Application for Works Approval Amendment

Works Approval Number	W6566/2021/1
Works Approval Holder	Evolution Mining (Mungari) Pty Ltd
ACN	002 124 745
File Number	APP-0033113
Premises	Mungari Gold Mine Kundana Road KALGOORLIE WA 6430 Mining tenements: L15/391, M15/1831 (partial), M15/1827 (partial), L15/387 (partial), M15/829 (partial), M15/830 (partial)
Date of Report	5 May 2026
Decision	Revised works approval granted

Figure 1: Location of Site Infrastructure

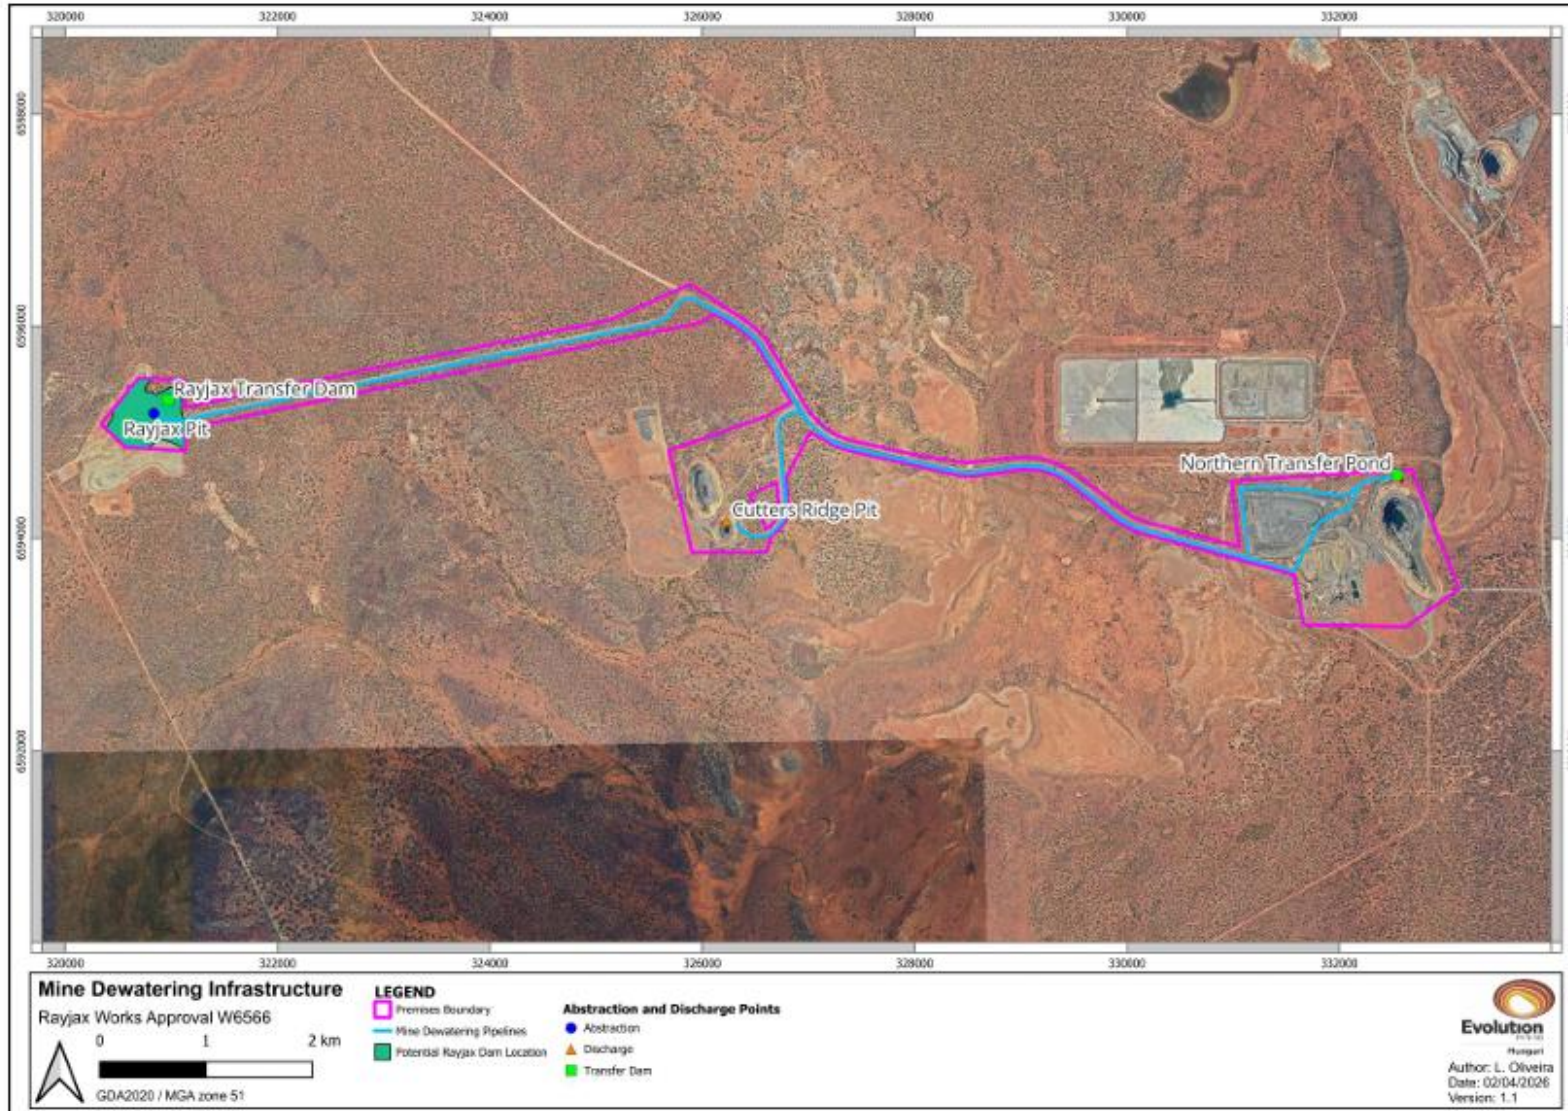
- Extend the duration of the works approval by 5 years to August 2031
- Modify existing approved pipelines to a revised diameter of 280 mm (previous assessed diameter of 160 mm)
- Addition of a new High Density Polyethylene(HDPE) lined transfer dam (Rayjax dam) with maximum capacity of 12540 m³. (Designed to include a minimum freeboard of 300 mm (freeboard not included in the 12540m³ capacity.)

The proposed Rayjax dam is intended to support mine dewatering activities by providing temporary storage of water transferred from Rayjax pit prior to pumping to Cutters Ridge pit or Northern transfer dam. The proposed location of the dam is displayed in Figure 1,

Condition no.	Proposed amendments
Cover page	Works Approval duration extended until 10/8/2031
1	Construction table updated to include: <ul style="list-style-type: none"> - Dewatering pipeline diameter of 280 mm - Construction requirements added for new HDPE Lined Transfer Dam.
New Figure 2	Figure 2 included to specify location of new site infrastructure
